# **HYNET CARBON DIOXIDE TRANSPORTATION AND STORAGE PROJECT - OFFSHORE**

**Technical Note: Marine Biodiversity – Benthic Subtidal and Intertidal  
Ecology (MBTN\_01)**

EHE7228B  
Liverpool Bay CCS Limited  
Version Rev01  
July 2024  
Offshore ES

Figure 1.2: Location of Cable Crossings within the Eni Development Area

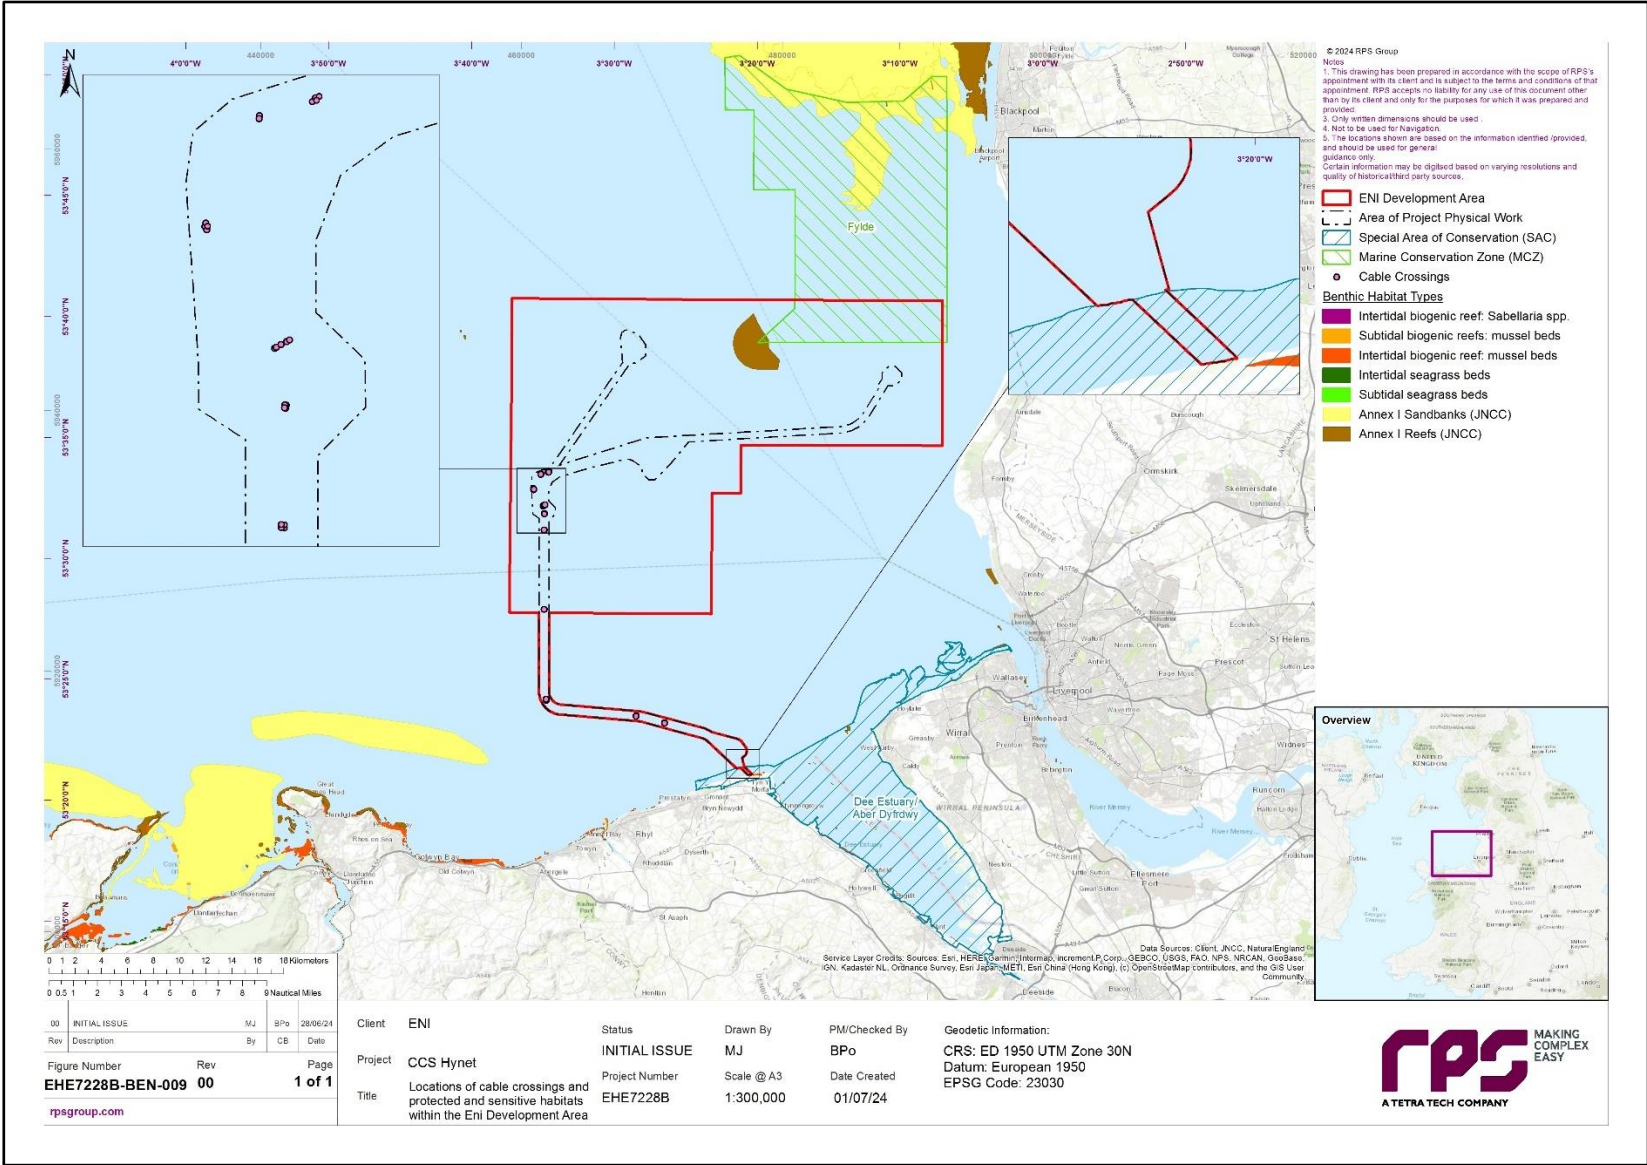
Natural England	The application states that the installation of cable crossings and their protections will account for 58,800 m <sup>2</sup> of long-term subtidal habitat loss. However, from the current cable crossing Maximum Design Scenario (MDS) parameters, it is not clear on where cable crossings will occur or the location of habitat loss. We advise that further information on cable crossings are provided (i.e. specific locations, total area of impact, overlap with Marine Protected Areas (MPAs)) and methodology in line with best practise guidance. The potential interruption of sediment transport and resulting morphological change due to the presence of cable crossings near sensitive receptors and pathways should also be considered in the ES.	The current proposed locations of cable crossings are presented in <b>Figure 1.2</b> . Planned cable crossings are located several kilometres from designated sites, and areas of sensitive benthic habitats, such as Annex I sandbanks and reefs. An assessment of the potential for cable crossings and associated protection to result in secondary scour is presented in <b>section 1.4</b> . This assessment indicates that impacts from cable crossings would be insufficient to disrupt sediment transport, seabed morphology, or cause secondary scour to develop. As such, no further assessment of this impact on subtidal benthic ecology receptors has been undertaken, and the assessment presented within the Application is considered appropriate.

As stated in the MDS within Volume 2, Chapter 7: Marine Biodiversity, cable crossings and their protection will account for up to 58,800 m<sup>2</sup> of long-term subtidal habitat loss. The proposed locations of cable crossings are presented in **Figure 1.2**. These are the locations for the cable crossings shown in the plans, cross-sections, and general arrangement drawings submitted with the Marine Licence application to describe Activity 02. The design information and maps **Figure 1.2** demonstrate that although the cable crossings are located within the Liverpool Bay SPA, they are multiple kilometres from any areas of sensitive benthic habitats, such as Annex I sandbanks and reefs.

Natural England and NRW also requested that the potential interruption of sediment transport and resulting morphological change due to the presence of the cable crossings should be considered. The worst-case MDS presented with in the ES showed that in total up to 32 cable crossings may be required, 10 of which relate to the PoA to Douglas OP Cable, eight for the Douglas to Hamilton Inter-OP cable, eight for the Douglas to Hamilton North Inter-OP cable, and six for the Douglas to Lennox Inter-OP cable. Depending on the heights of such cable crossings, and the water depth, there can be potential for changes to tide, wave and sediment transport processes due to a changed seabed morphology through altered bed levels. In this case however cable crossings will be up to a maximum height of up to 0.8 m, with widths of 7 m and tapered profiles to reduce the impacts to sediment transport and seabed morphology. The cable crossings will be required in a range of depths from approximately 5.8 to 30.3 m Chart Datum (CD).

Where practicable, the cable crossing requirements will be compliant with the Maritime and Coastguard Agency (MCA) navigation guidance which includes that there will be no more than a 5% reduction in water depth (referenced to CD) at any point along the cable route (MCA, 2021). To exemplify the limited extent of changes to sediment transport and seabed morphology due to the presence of cable protection and altered seabed morphology are expected to be, potential changes to the wave climate may be considered. Although wave climate did not form part of the modelling presented in Volume 2: Physical Processes Technical Report, studies undertaken within the vicinity of the Eni Development Area can be drawn upon. The physical processes modelling for the Mona Offshore Wind Project indicated that where the cable protection height was less than 15% of the water depth there was no change in wave climate (Mona Offshore Wind Ltd, 2024a; Mona Offshore Wind Ltd, 2024b). In compliance with the MCA navigation guidelines discussed above, the maximum height of the shallowest cable crossing would be restricted to 5% of the water depth and therefore is likely to exhibit no change in wave climate, however, given the majority of cable crossings fall within waters deeper than 25 m (CD), water depths will be changed by less than 5%. With most of the crossings falling in waters of 25 m (CD), which equates to 28 m mid tide, the introduction of 0.8 m height cable crossings represents less than a 3% change in water depth and therefore likely < 3% change to tidal currents. This change is 25% of that exhibited in the natural variation between peak spring and peak neap tidal flows.

Therefore, due to the small scale of the cable crossings, the distance of cable crossings from sensitive features and designated sites, designed in mitigation measures such as tapered profiles, and compliance with the MCA navigational guidance, it is not expected that impacts from cable crossings would be sufficient to disrupt sediment transport, seabed morphology, or cause secondary scour to develop. As such, no further assessment is required with regards to impacts of secondary scour resulting from cable protection at cable crossings on subtidal benthic ecology receptors.
